## City of Craig

**To:** City Administration/City Council  
**From:** Carl R. Ray  
**cc:** Mark Sollenberger, Liz White  
**Date:** 10/23/20  
**Re:** WWTP Handrail Replacement Project

**RE: Bid Evaluation Recommendation – Wastewater Treatment Plant Handrail Replacement Project**

## ADDENDUM ORDER

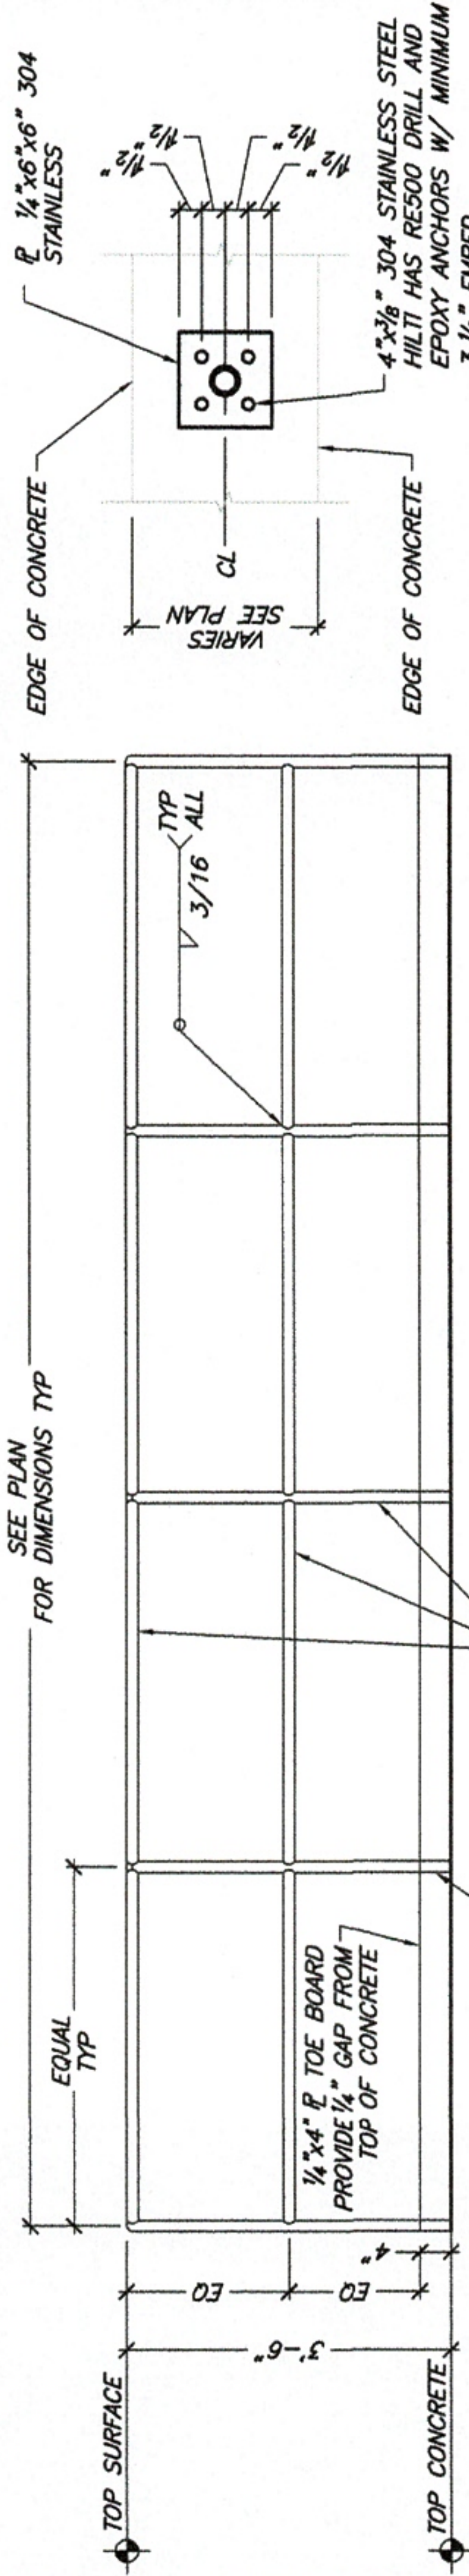
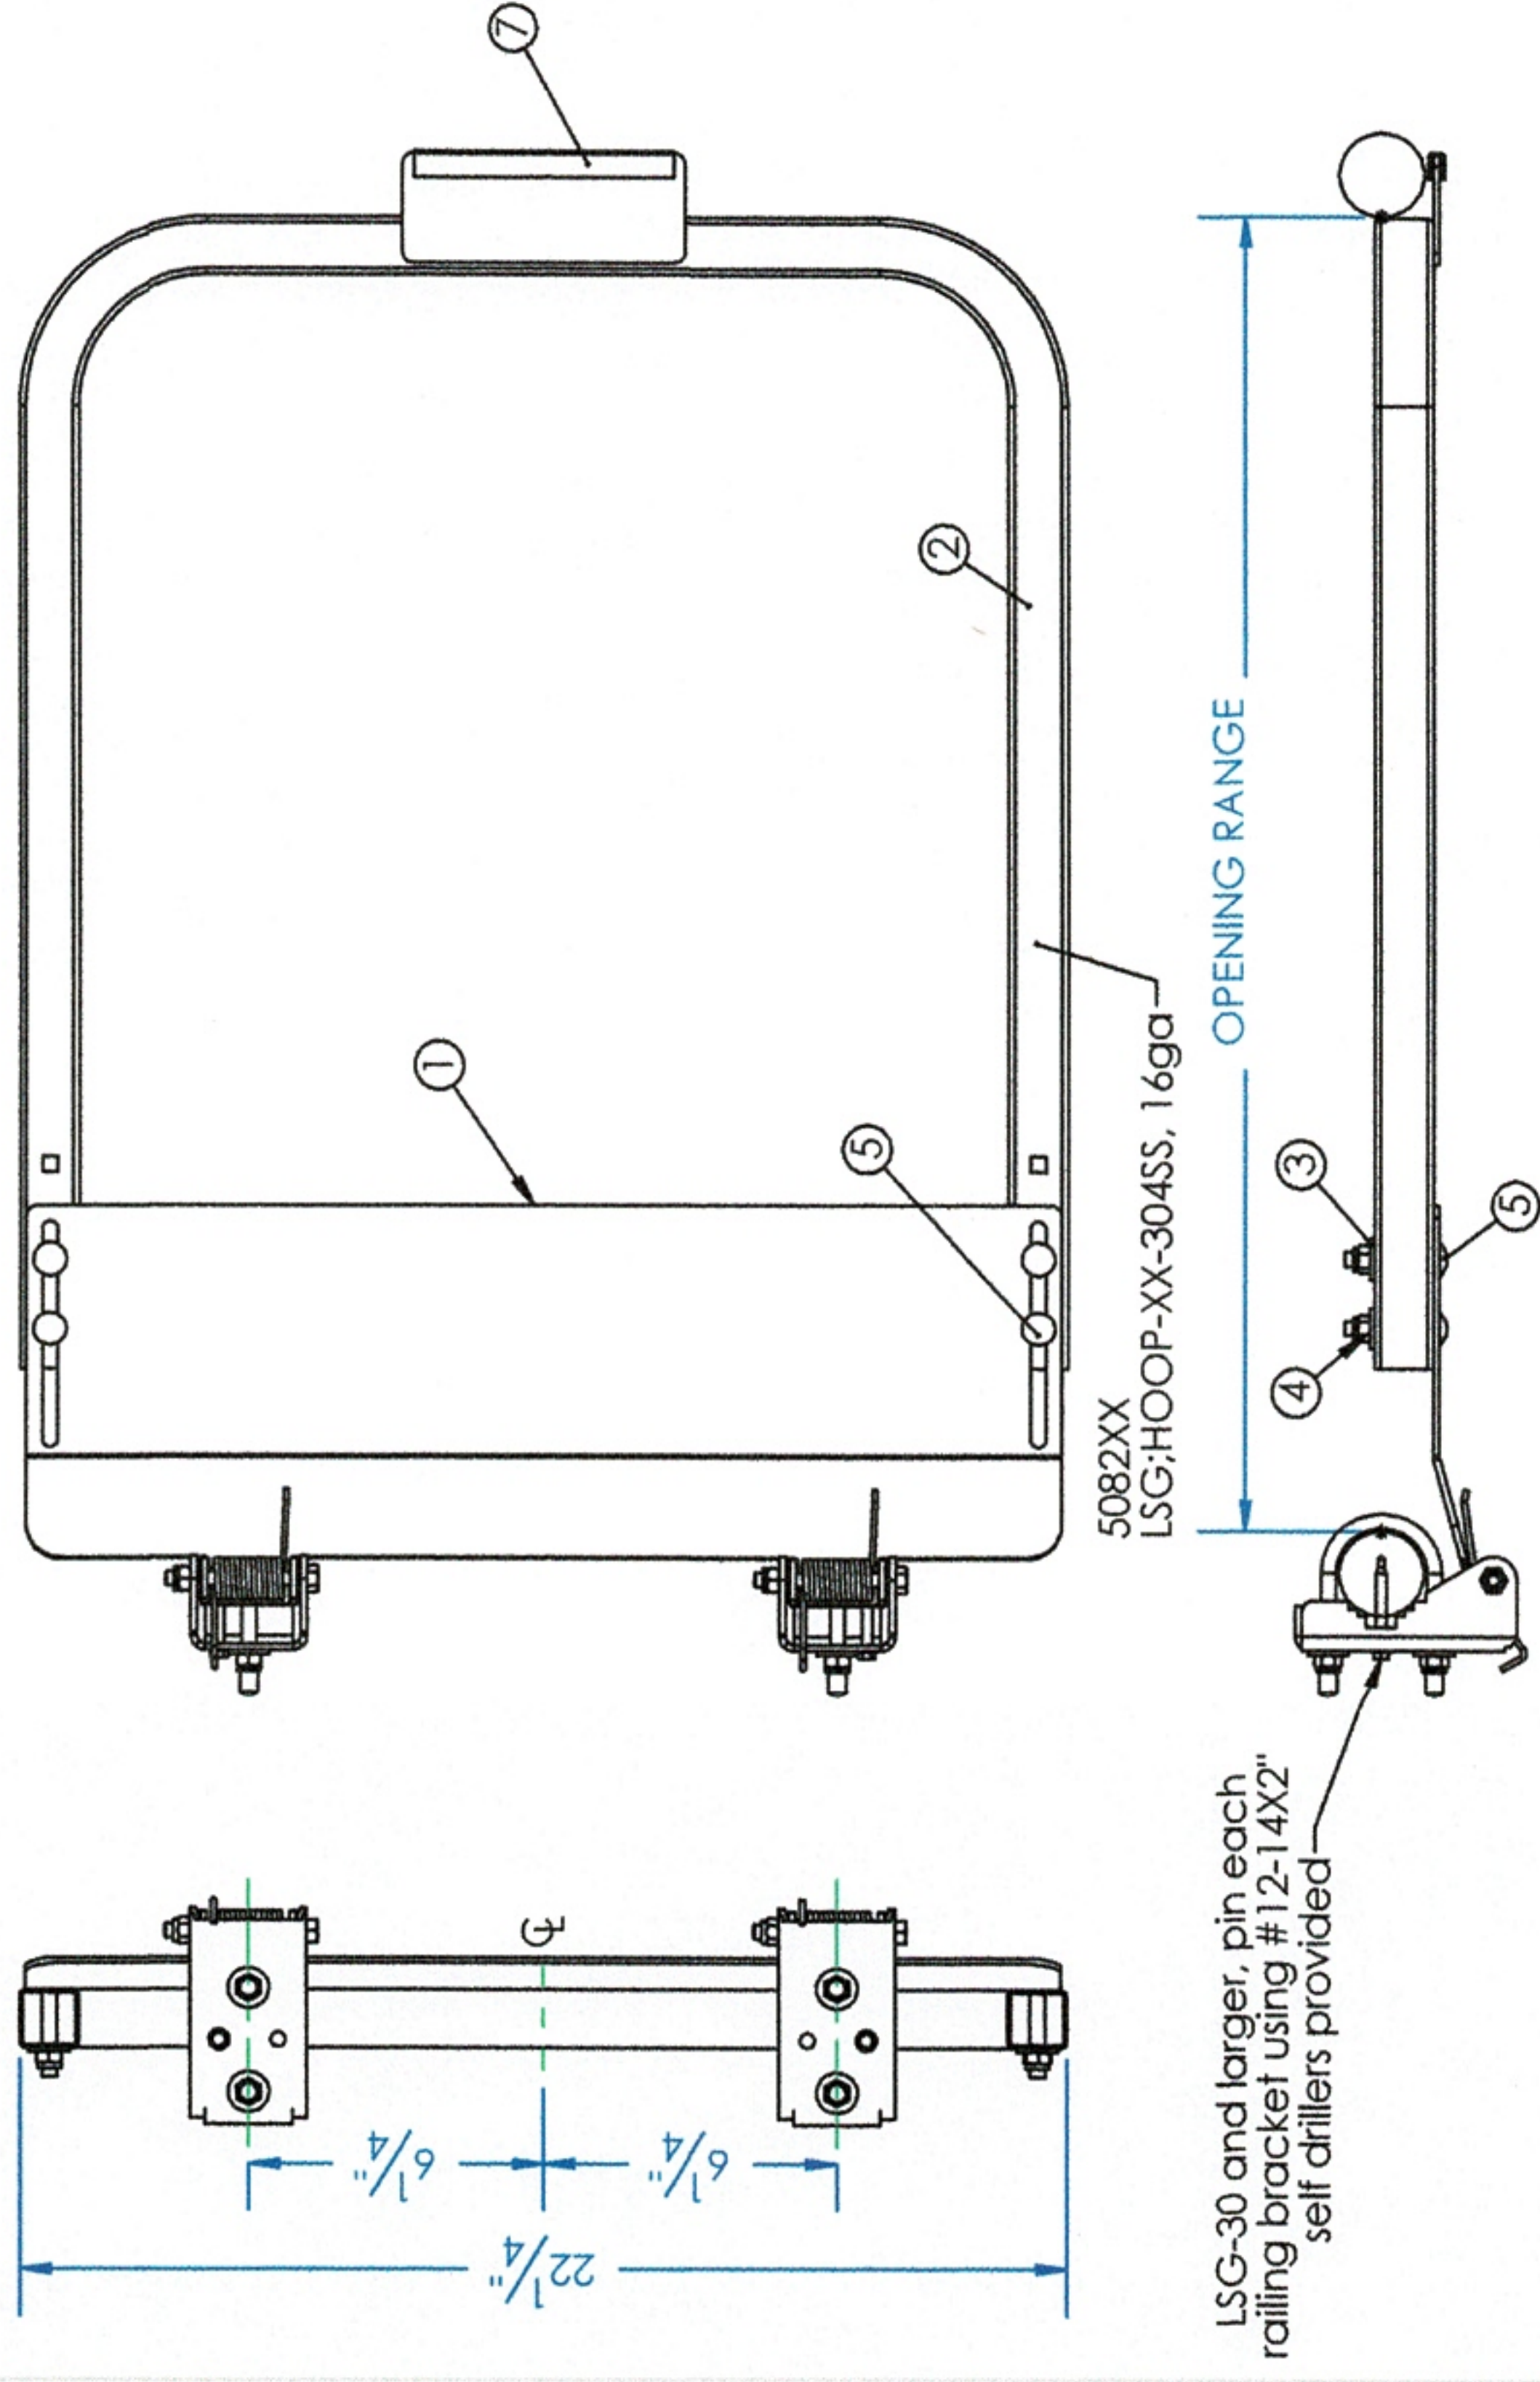
1. Specification Section 00300, Bid Form. Line Item 5 added for addition of Wet Well Toe Plate.
2. Specification Section 01025, Measurement and Payment. Section 1.08.E added for Bid Line Item #5 – Wet Well Toe Plate.
3. Additional handrail details provided on Drawing Sheet S1.

9. REFER TO DETAIL 1 FOR HANDRAIL REQUIREMENTS; REFER TO DETAIL 2 FOR MOUNTING REQUIREMENTS.

Sheet No. S1

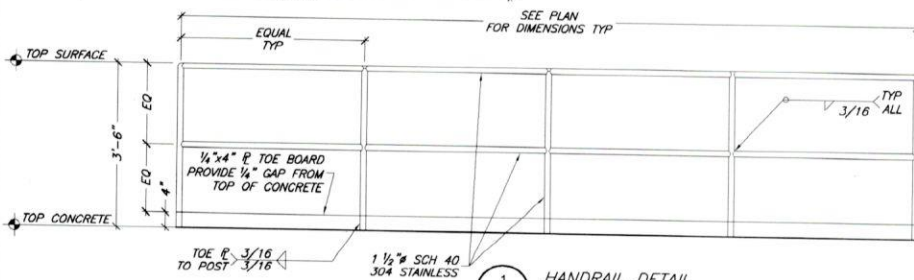
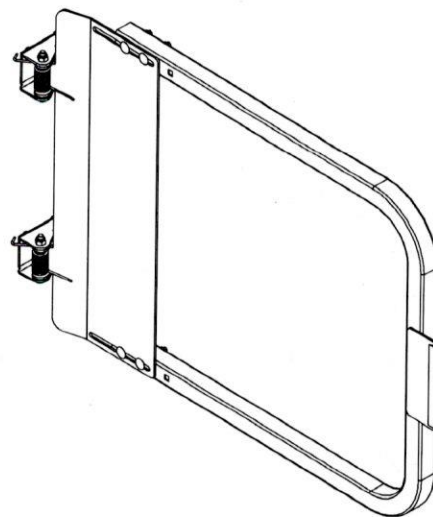
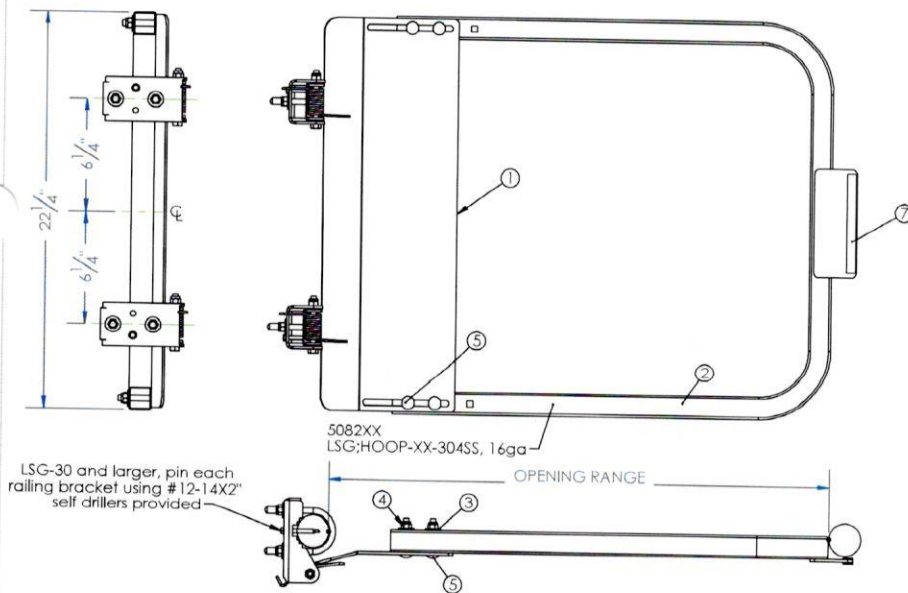
1. Specification Section 00300, Bid Form. Line Item 5 added for addition of Wet Well Toe Plate.
2. Specification Section 01025, Measurement and Payment. Section 1.08.E added for Bid Line Item #5 – Wet Well Toe Plate.
3. Additional handrail details provided on Drawing Sheet S1.
